## MEMORANDUM

**DATE:** August 20, 2015

**SUBJECT:** Construction of a 5-story multiple-family dwelling with 215 dwelling units (477 bedrooms) and 147 parking spaces at 117 27<sup>th</sup> Avenue Southeast

Re: Essex and 27th Ave SE Redevelopment

**B EAST ELEVATION (ALONG 27TH AVE SE)**  
A5 1" = 30'-0"

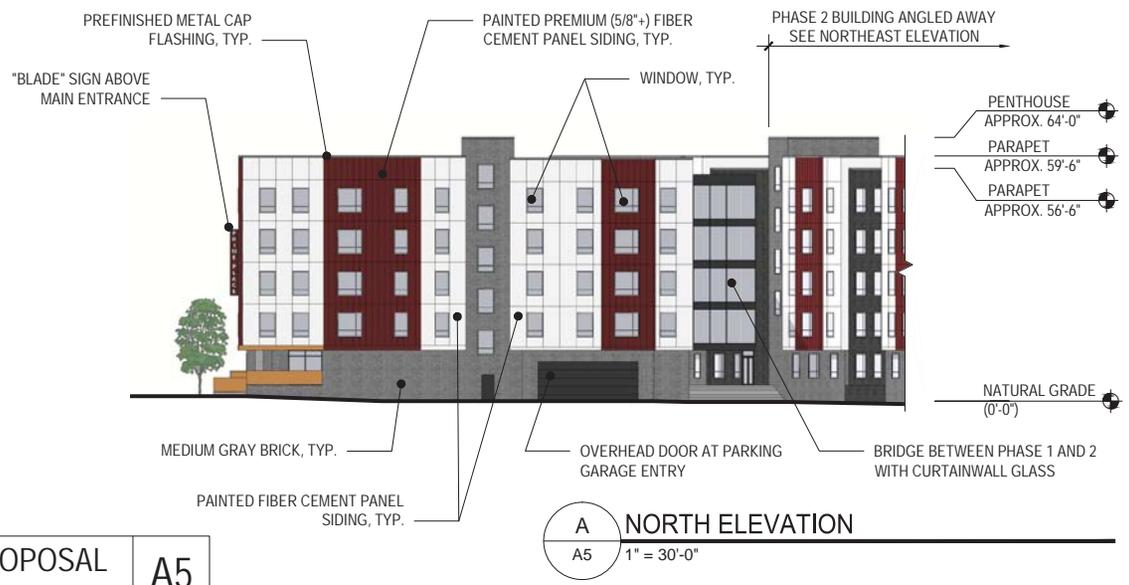
- Section 530.120-Building Design states that multiple entrances shall be encouraged? The current plan has two entrances along 27<sup>th</sup> Avenue Southeast. Would you like to see additional entrances and walkup apartments along 27<sup>th</sup> Avenue Southeast?

- Section 530.120-Building Design states that 20 percent of the walls on the first floor that face a public street shall be windows. Minimum window area at the first floor shall be measured between two and ten feet above adjacent grade. Given the current building design and first floor height, the project may not meet this requirement. Are you supportive of requiring that the project meet the 20 percent window requirement along 27<sup>th</sup> Avenue Southeast?
